**Addendum #1**

**PROJECT #:** ST-0046-B01  
Millville High School Additions and Alterations  
Millville Public School District

**DESCRIPTION:** Addendum #1

**4'-0" SINGLE TRAP (PO-1 & PO-2)**  
N.T.S.

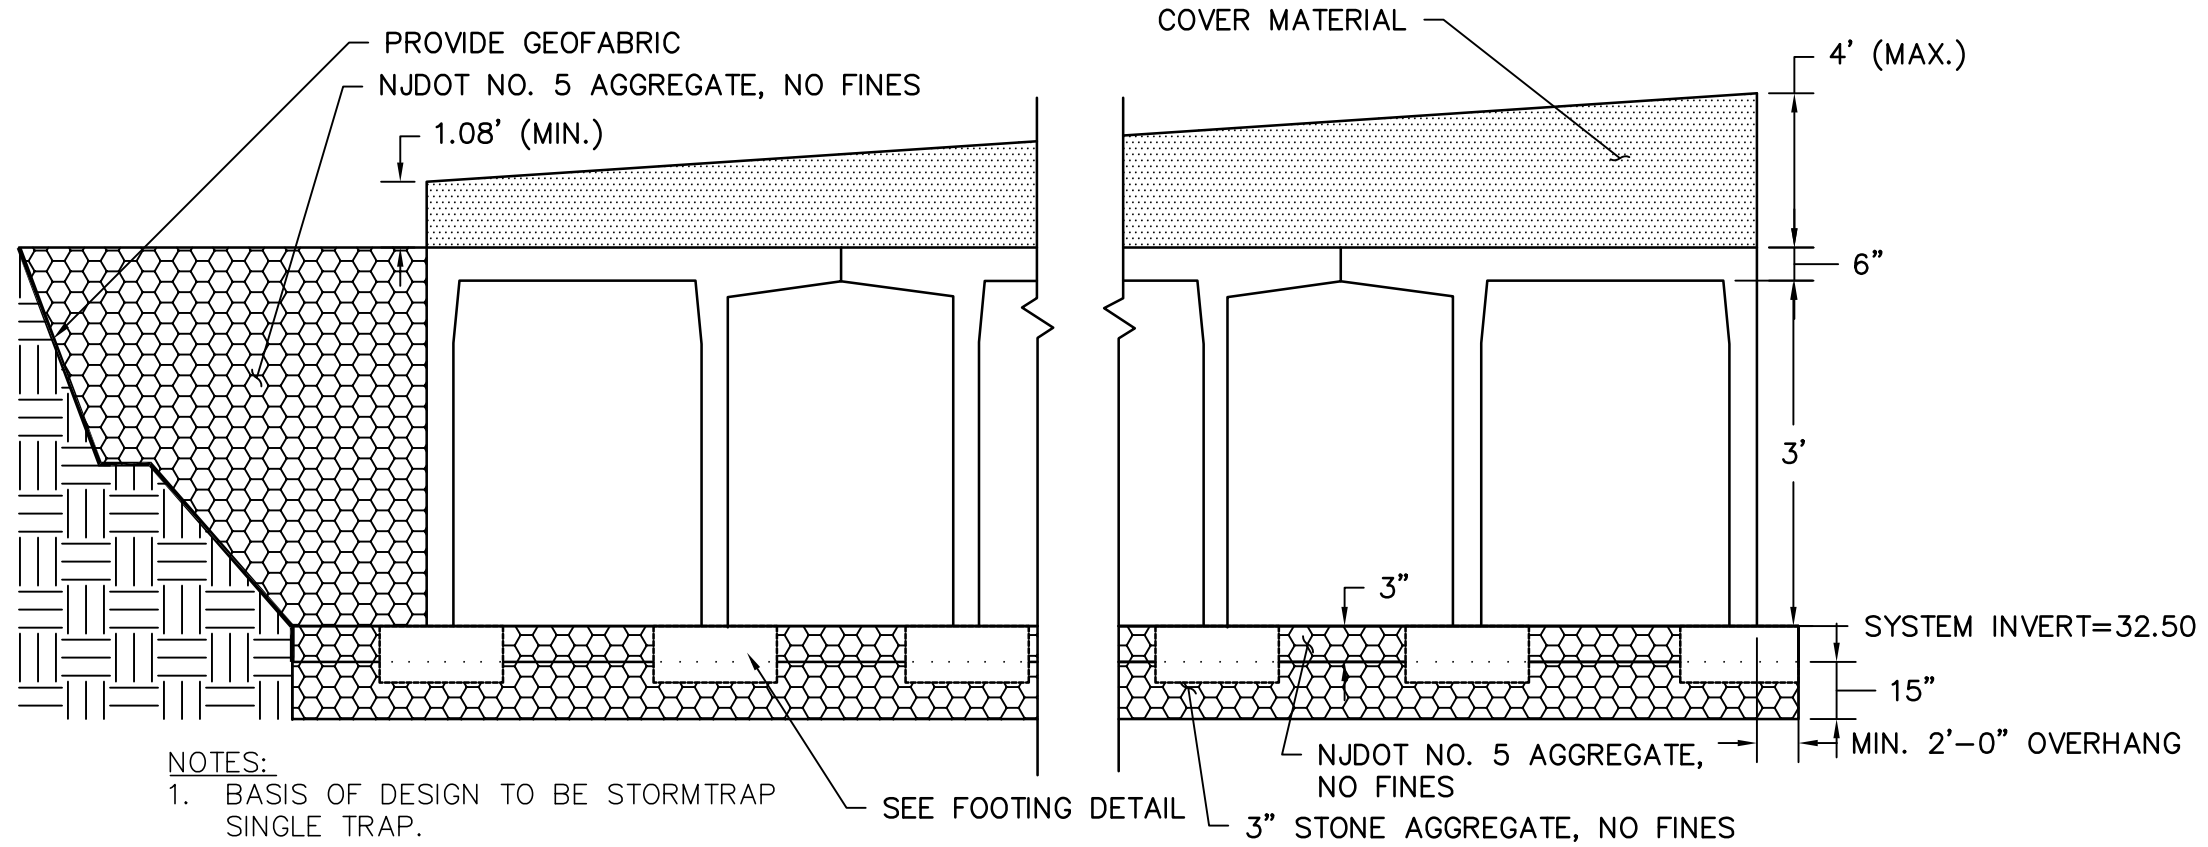
**70.** Question: The Storm Trap details on Drawing C3.6 indicate 3'-0" Storm Trap units and the layout provided on Drawing C3.7 indicates 4'-0" Storm Trap units. Please clarify.

Answer: PO-1, and PO-2 are 4-ft Storm Trap Systems. PO-3 is a 3-ft Storm Trap System. See SK-02 for additional dimensions, issued herewith as Attachment #1.3.

### 3'-0" SINGLE TRAP (PO-3)

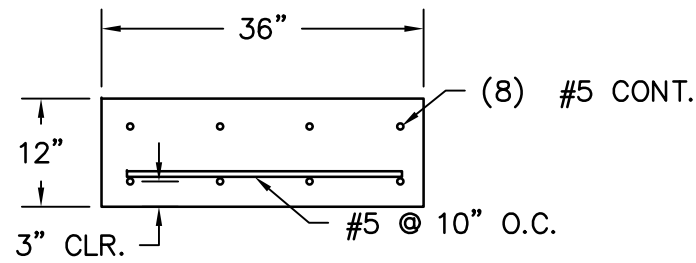
**69.** Question: The Storm Trap details indicated on Drawing C3.6 provide dimensions that appear to be incorrect. Please update.

**71.** Question: Based on the groundwater depth of el. 30 (taken in November 2015) in the Geotechnical Field Investigation Report and the stormwater catch basin inverts indicated in Drawing C3.3, the infiltration basis (P0-3) will be located at a depth that would not provide the minimum 2-foot buffer from the groundwater table per NJDEP requirements. Please advise.

Answer: See SK-01 for corrected dimensions, issued herewith as Attachment #1.2.

Answer: In the location of PO-3, groundwater elevation of 29.50 was taken to be the highest observed from borings B-1, B-12, & B-16. Bottom elevation of storm volume storage is 32.50 (difference of 3'-0").
